# CITY OF ALBUQUERQUE

June 14, 2019

RE: **7901 Las Lomas NE**  
**Grading Plan Stamp Date: 6/6/19**  
**Drainage File: D16D002I**

Based on the submittal received on 6/6/19, the grading plan cannot be approved until the following corrections are made:

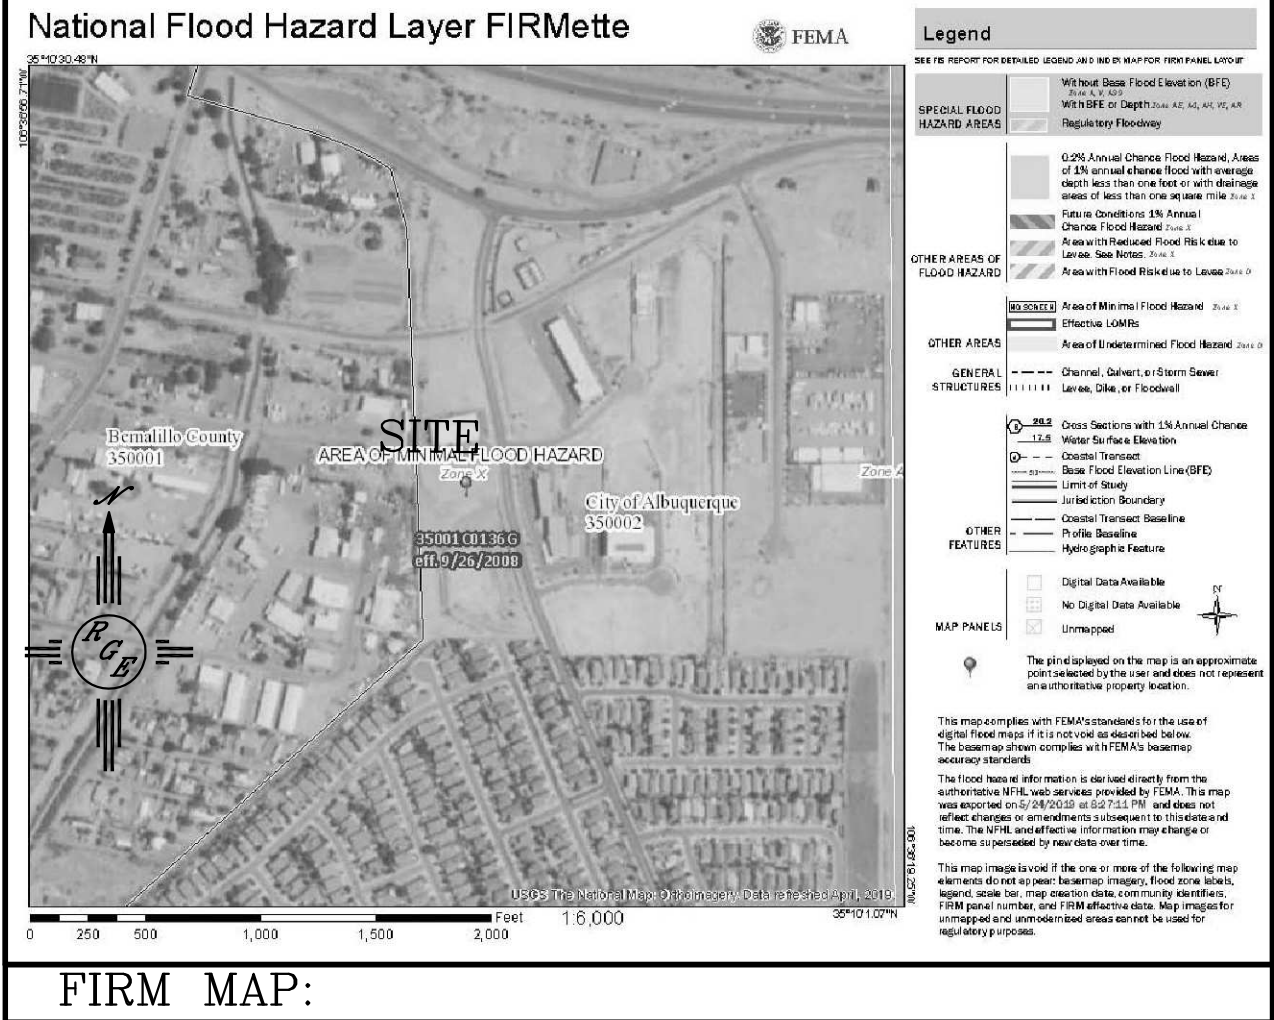
1. This lot got re-subdivided since the master plan and is now a 1-acre lot (43577.65SF). Hydrology, allowable discharge rate, SWQV, Hydraulics, etc.... all will all need to be updated and a revised plan submitted.

3. Legal description is incorrect.

4. The Master Plan shows this property discharging entirely to the street, so the plan to convert the manhole to an inlet and drain west won't be acceptable.

5. Is the rock plating detail for the steep west and south slope? If so, it should be called out.
